MS-7C52 Ver:1.0

CPU:
AMD AM4
System Chipset:
Promontory A320
(Value DIY or System Builder)

FUSION BLOCK DIAGRAM

SPI ROM (1.8V)

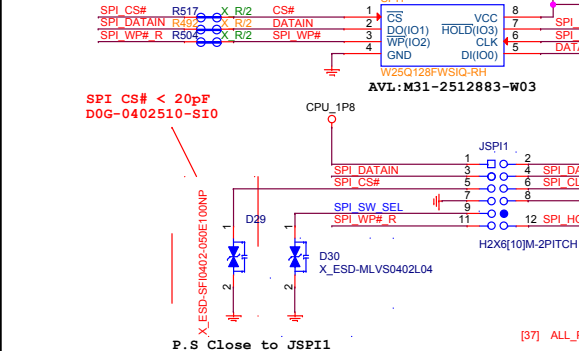
R492, R525 are changed to 0ohm to short copper by cost reduction.

The footprint of SPI1 is changed to SIC8_SST_S2A.COLAY_T by 16M/32M colay by PM spec

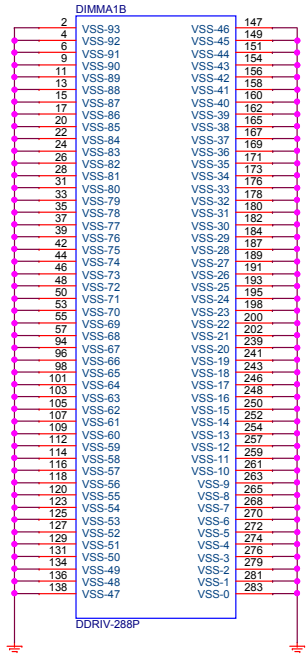
2018/5/13
The footprint of DIMMA1 is changed to DDRIV_D288_1_T_7A17 by the latest result from Ryan's comment

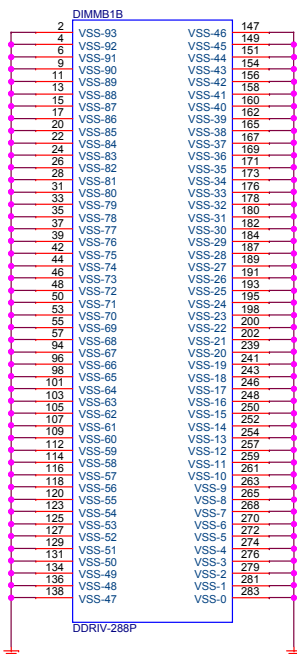
2018/5/13
The footprint of DIMMB1 is changed to DDRIV_D288_1_T_7A17 by the latest result from Ryan's comment

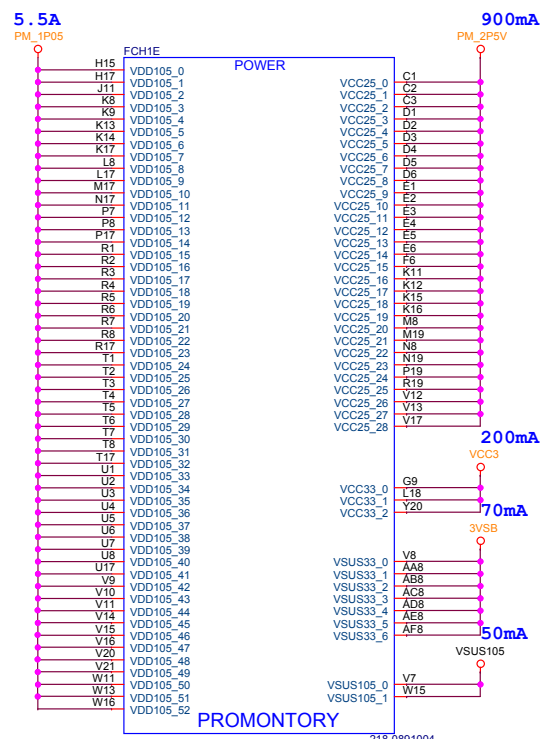
2019/4/30
L24, L23, L25, L30, L26, L28 are changed to 0ohm by Ryan's comment.
2019/4/30
B450 SKU is added by PM spec updated

2019/5/8
L25 is deleted by cost reduction

2019/5/8
L30 is deleted by cost reduction

2019/5/8
L26 is deleted by cost reduction

2019/5/8
L28 is changed to 0ohm to short copper by cost reduction.

PCI EXPRESS x16 Slot

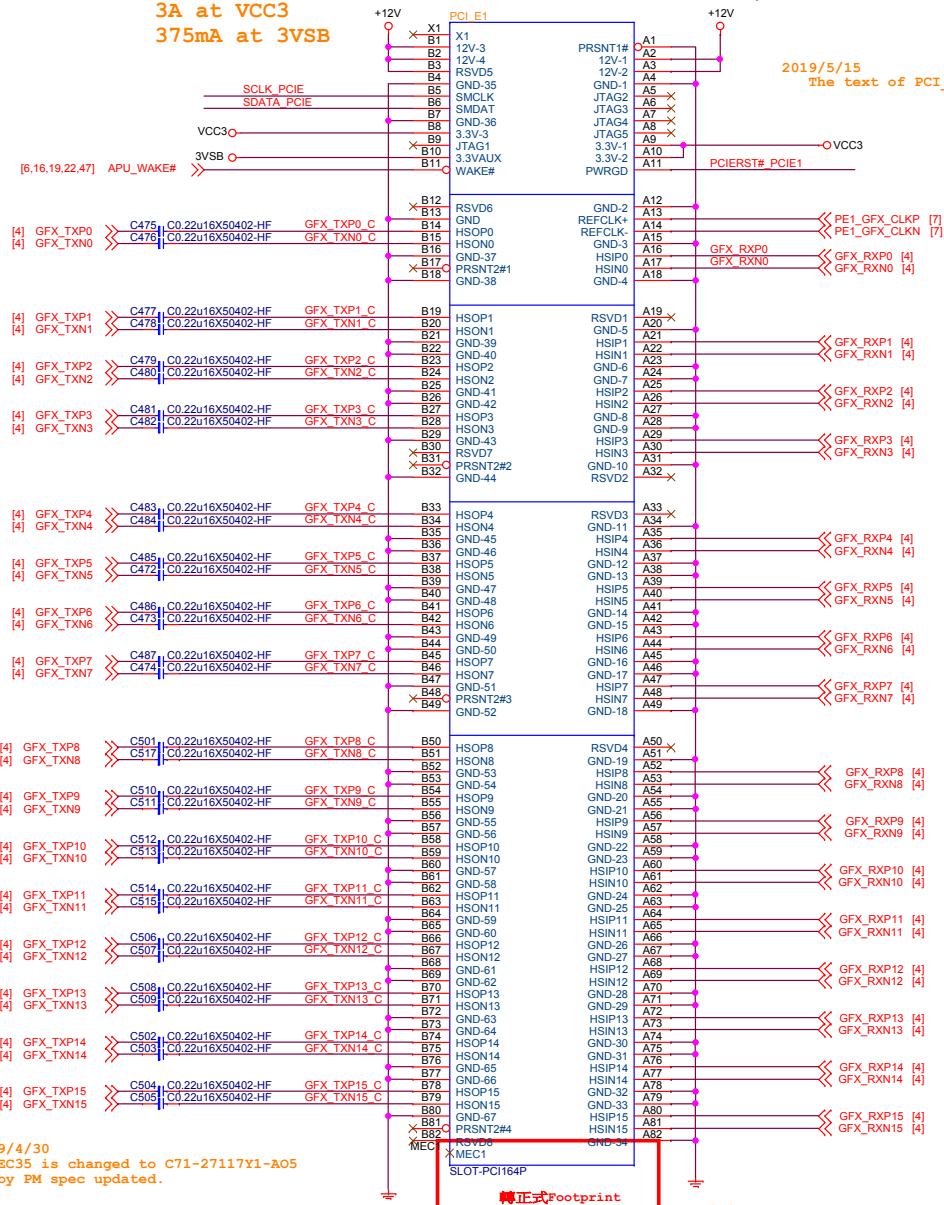
2019/5/15
The text of PCI_E1 & PCI_E2 are swapped by PM's comment

FAN(direct PWM mode_)

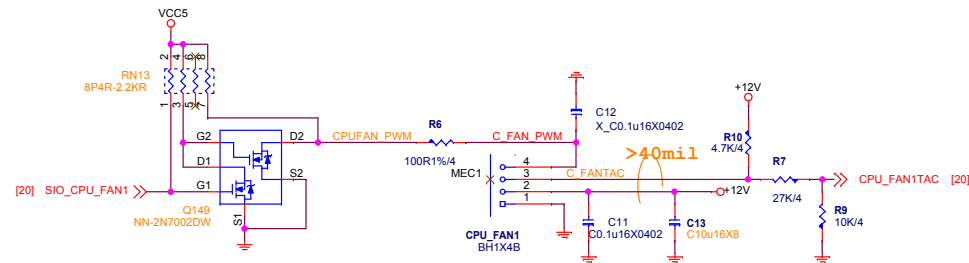
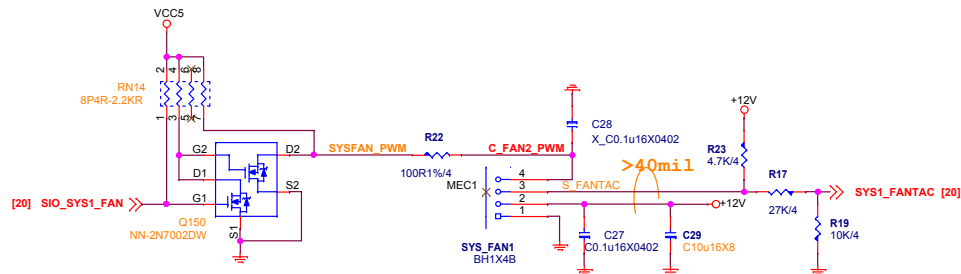
2019/4/15
U2, C5, R8, C9, C23 are deleted; R1517, R1518, Q149 are added; R4 is changed to 2.2Kohm by PM spec.
2019/4/15
C13 is changed from 22uF to 10uF; D5, C10, C6 are deleted by the latest module circuit
2018/5/9
R1517, R1518, R4 are deleted and then RN13 is added by cost reduction.

2019/4/15
U3, C14, R21, C20, C32 are deleted; Q150, R1520, R1519 are added; R20 is changed to 2.2Kohm by PM spec
2019/4/15
C29 is changed from 22uF to 10uF; D8, C21, C15 are deleted by the latest module circuit
2018/5/9
R1520, R1519, R20 are deleted and then RN14 is added by cost reduction.

PS2

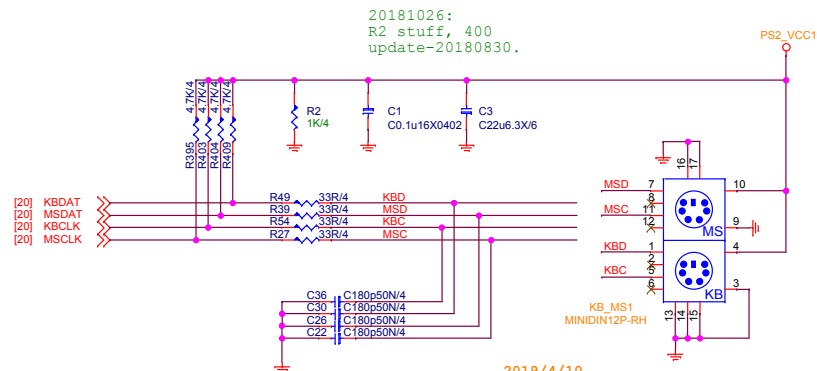
2019/4/10
About PS2 circuit move from the page 25
2019/4/10
KB_MS1 is changed to N56-12F0151-H06 by PM spec.

Type B: ALC892/887

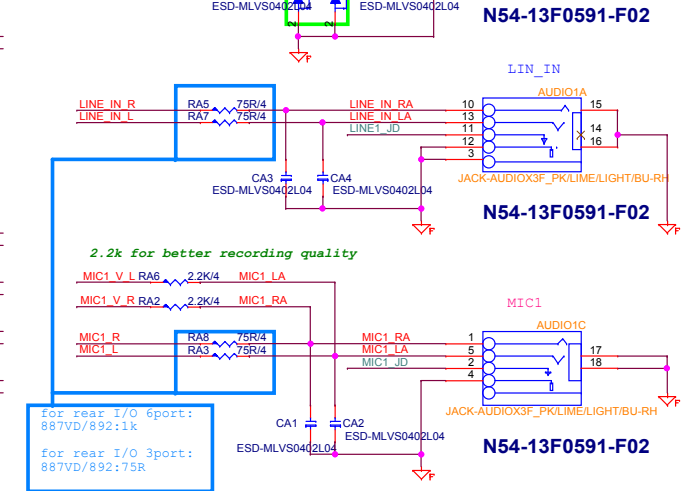
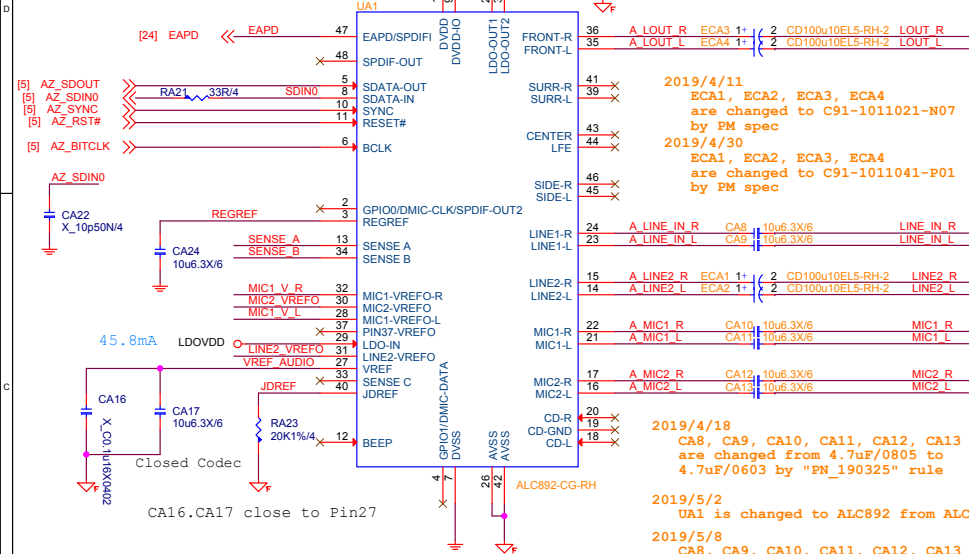
AUDIO is changed to N54-13F0591-F02 by PM spec.

2019/5/2
LA1 is unstuffed; LA8 is added; DA3 is connected from ATX_5VSB to LDOVDD by Robert's comment

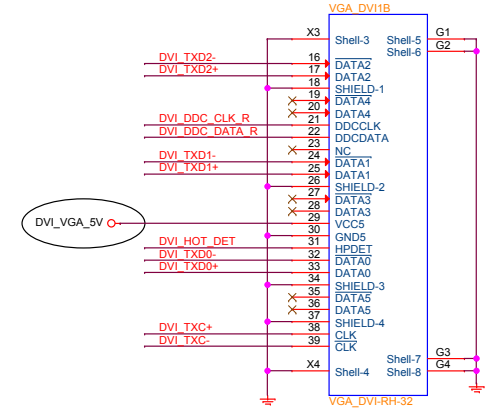
2019/4/10
VGA_DVI1 is changed to N58-43F0111-EB6 by PM spec.

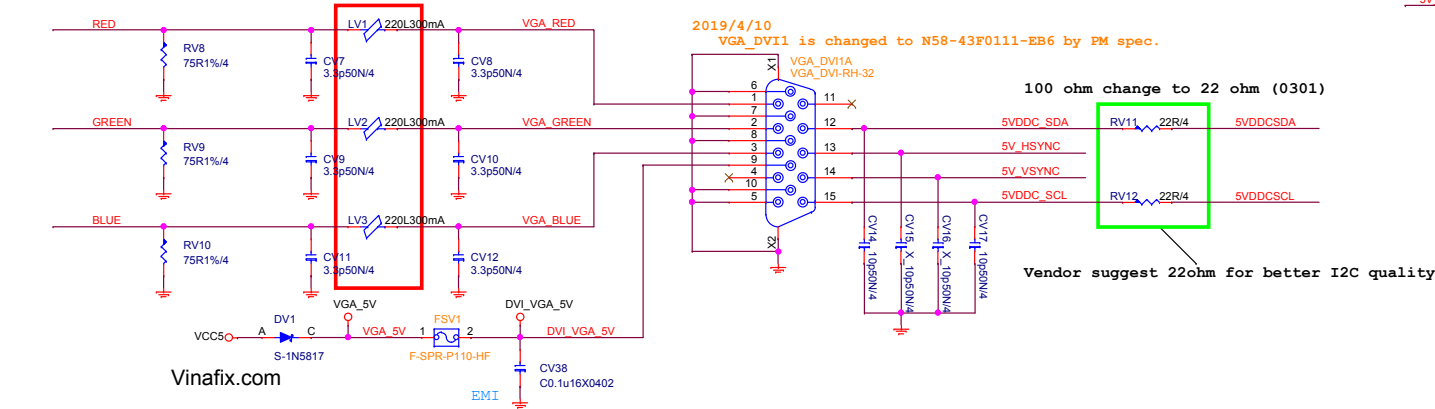
2019/5/6
FSV1 is changed to D08-0101700-P16 by Ivy's comment

5VDIMM FOR DDR

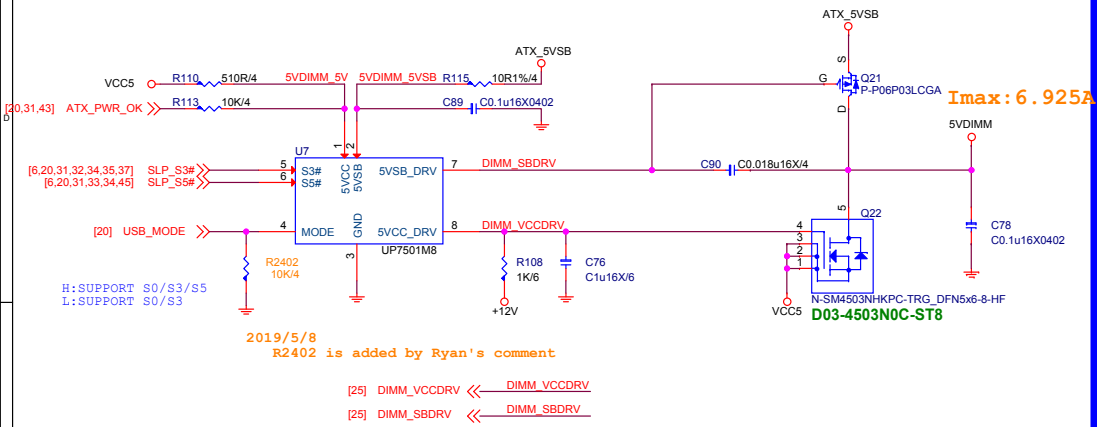
2019/5/8
R2402 is added by Ryan's comment

5VDUAL For 3VSB · CPU 1.8V · VDDP

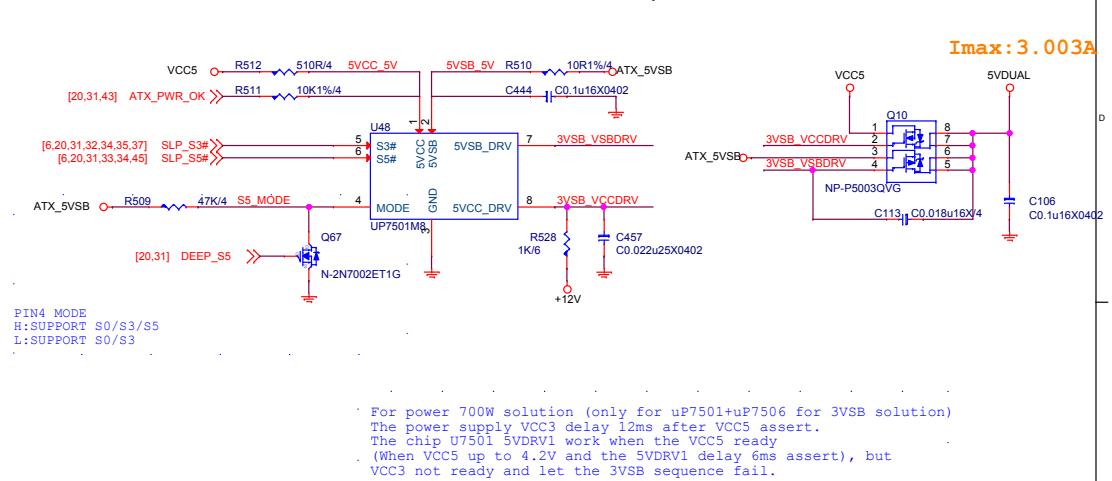
2019/4/17
R60, C79, Q9, R55, C67 are deleted by Ryan's comment

3VSB cost down

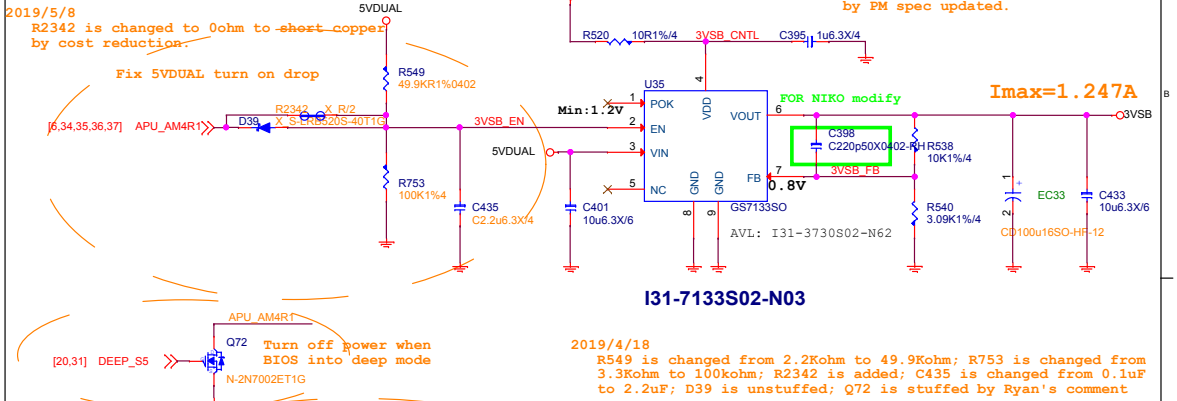
2019/4/18
R549, Q2, R62, Q81, R114 are deleted by Ryan's comment

CPU 1P8V S5

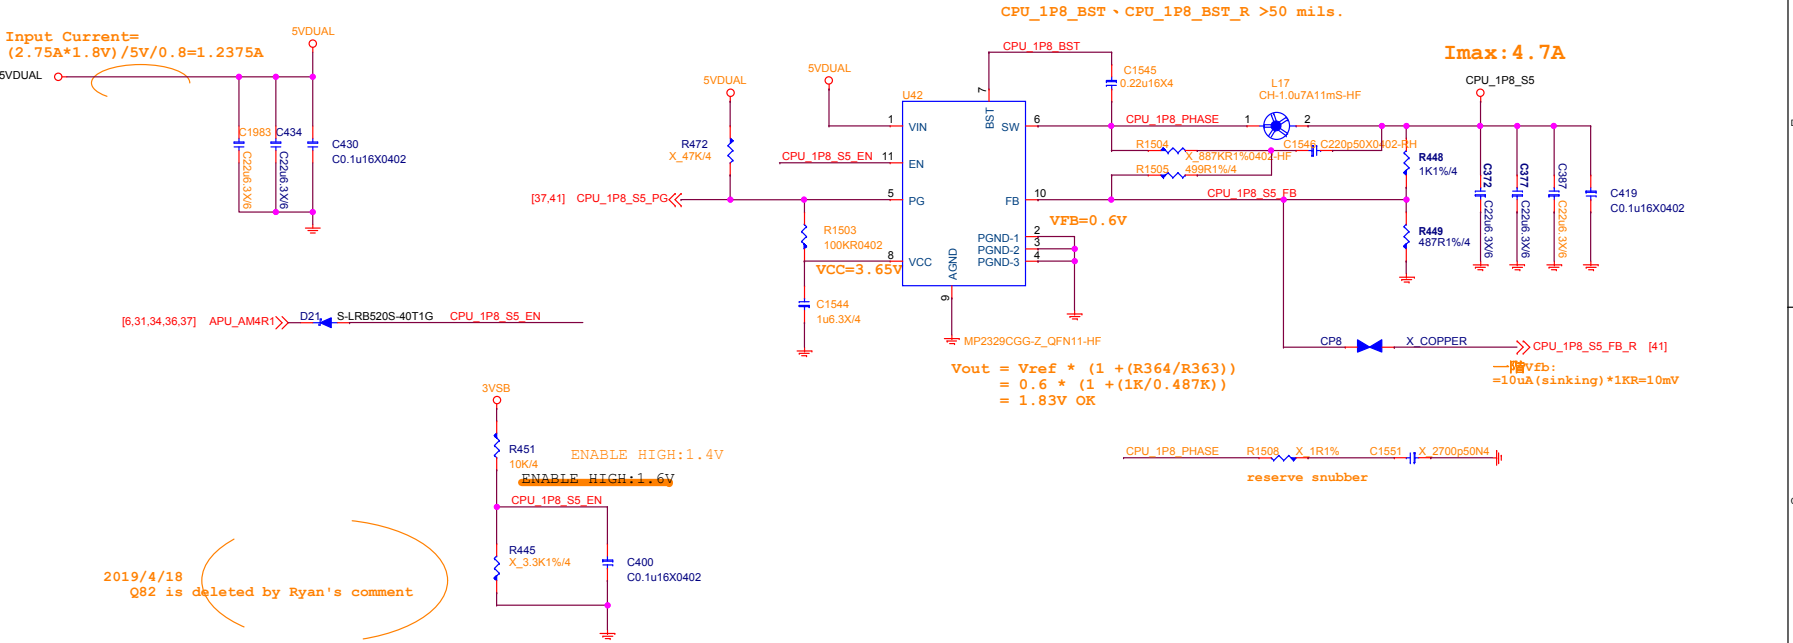
2019/4/12
L19, R479, R469, C423, C394 are deleted; R451 is changed from 2.2Kohm to 10Kohm; R445 is unstuffed; R472 is unstuffed; R1503, C1544, C1545, C1546, R1505 C1983 are added; U42 is changed to MP2329; R1504, R1508, C1551 are reserved; C387 is changed from 0.1uF to 22uF by Ryan's comment

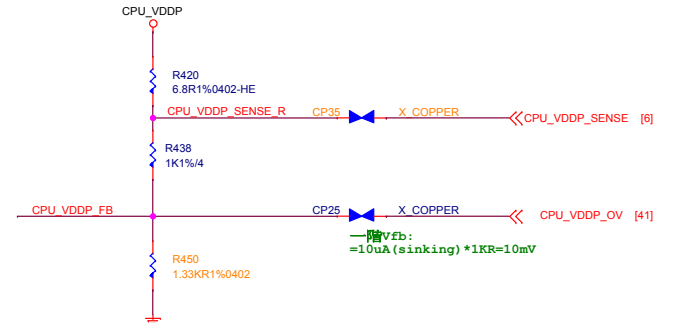
2019/4/25
CHOKE13 is changed to L04-68B7350-T15
by Ryan's comment

ALL POWER GOOD MUX

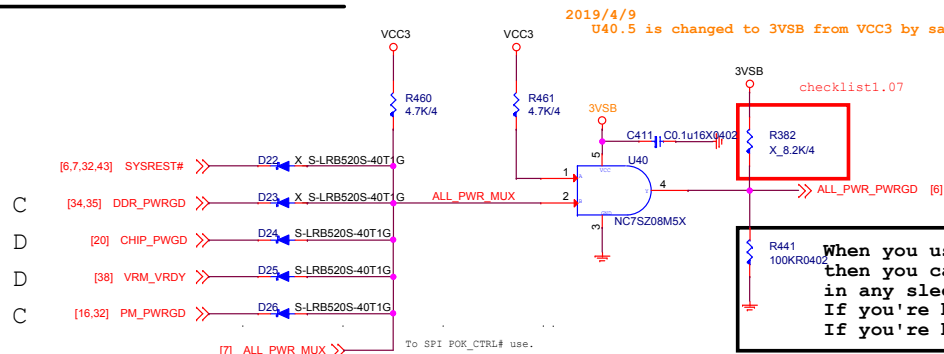
2019/5/20 Q11.G2 and Q11.G1 are swapped by Ryan's comment

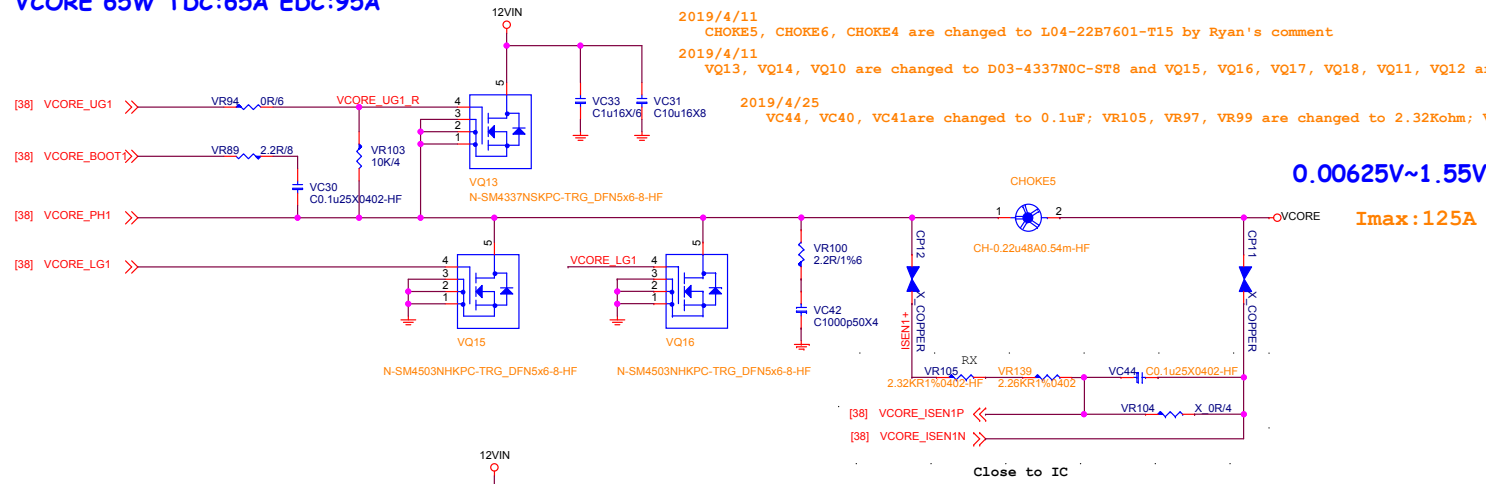
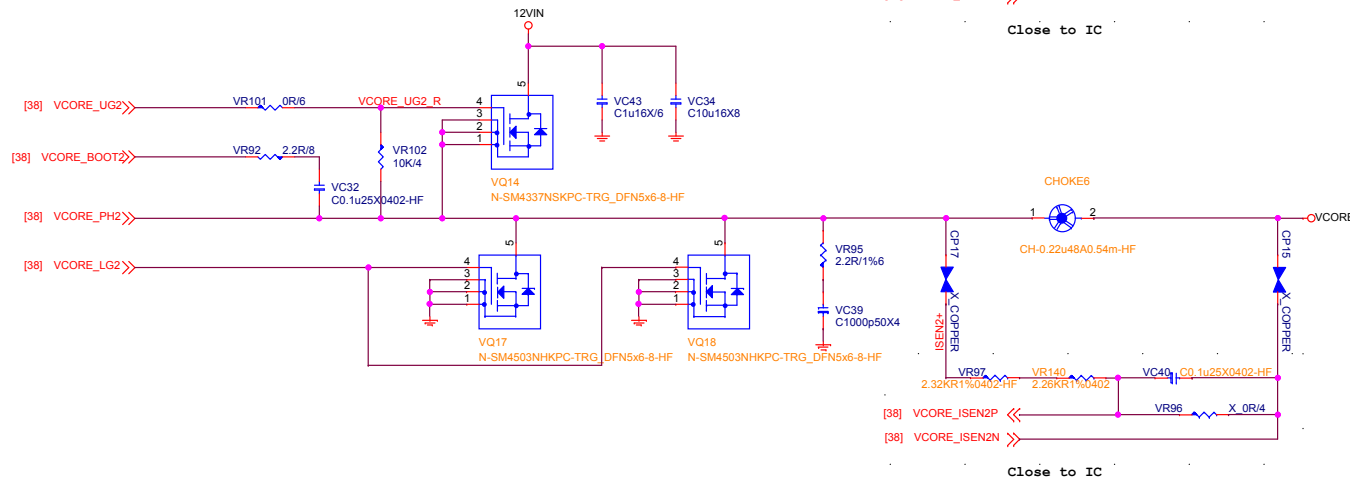
2019/4/11
CHOKE5, CHOKE6, CHOKE4 are changed to L04-22B7601-T15 by Ryan's comment

2019/4/11
VQ13, VQ14, VQ10 are changed to D03-4337N0C-ST8 and VQ15, VQ16, VQ17, VQ18, VQ11, VQ12 are changed to D03-4503N0C-ST8 by Ryan's comment(same as 7A36-3.0)

VC44, VC40, VC41 are changed to 0.1uF; VR105, VR97, VR99 are changed to 2.32Kohm; VR139, VR140, VR141 are added to 2.26Kohm by vendor's suggestion

EC40, EC42, EC45, EC46, EC47, EC48 are changed to C71-56106K1-A05 by PM spec updated

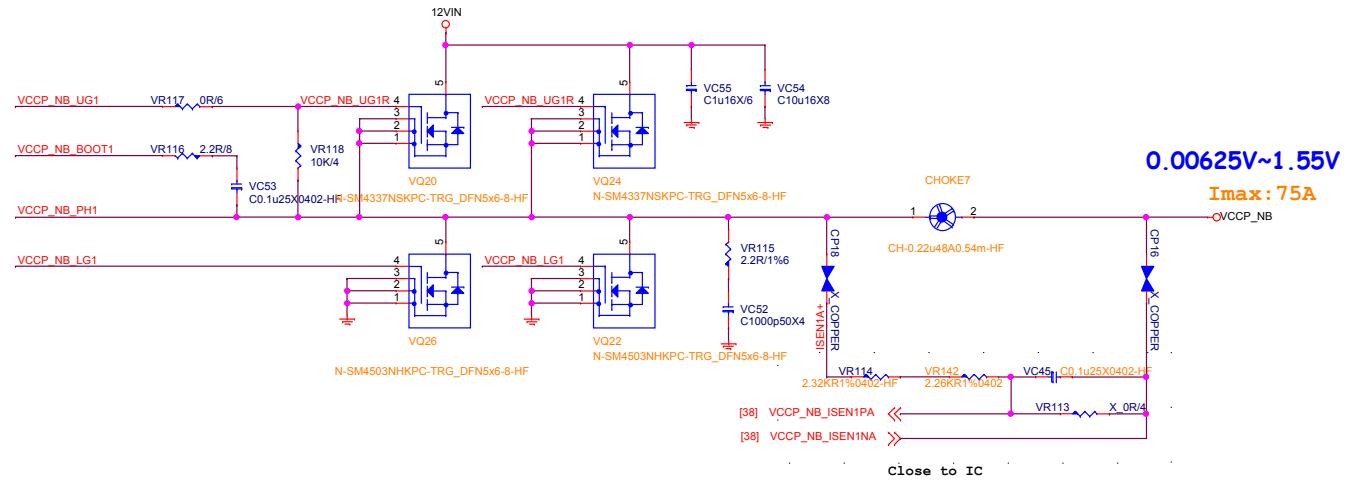
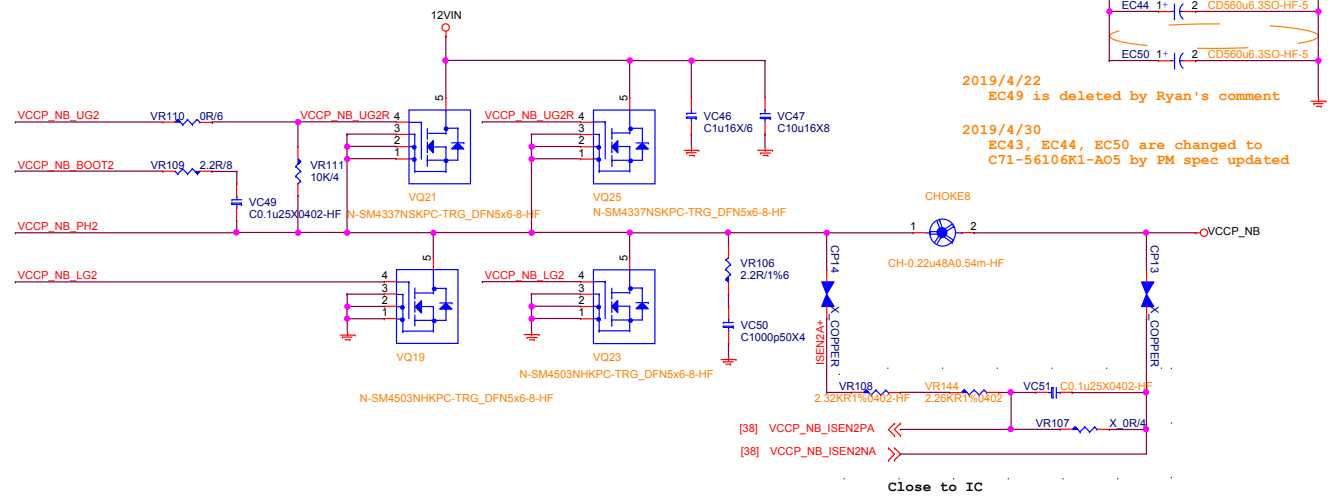
2019/4/11
CHOKE7, CHOKE8 are changed to L04-22B7601-T15 by Ryan's comment

2019/4/11
VQ20, VQ24, VQ21, VQ25 are changed to D03-4337N0C-ST8 and VQ22, VQ26, VQ19, VQ23 are changed to D03-4503N0C-ST8 by Ryan's comment(same as 7A36-3.0)

2019/4/25
VC45, VC51 are changed to 0.1uF; VR114, VR108 are changed to 2.32Kohm; VR142, VR144 are added to 2.26Kohm by vendor's suggestion

2019/4/22
EC49 is deleted by Ryan's comment

2019/4/30
EC43, EC44, EC50 are changed to
C71-56106K1-AO5 by PM spec updated
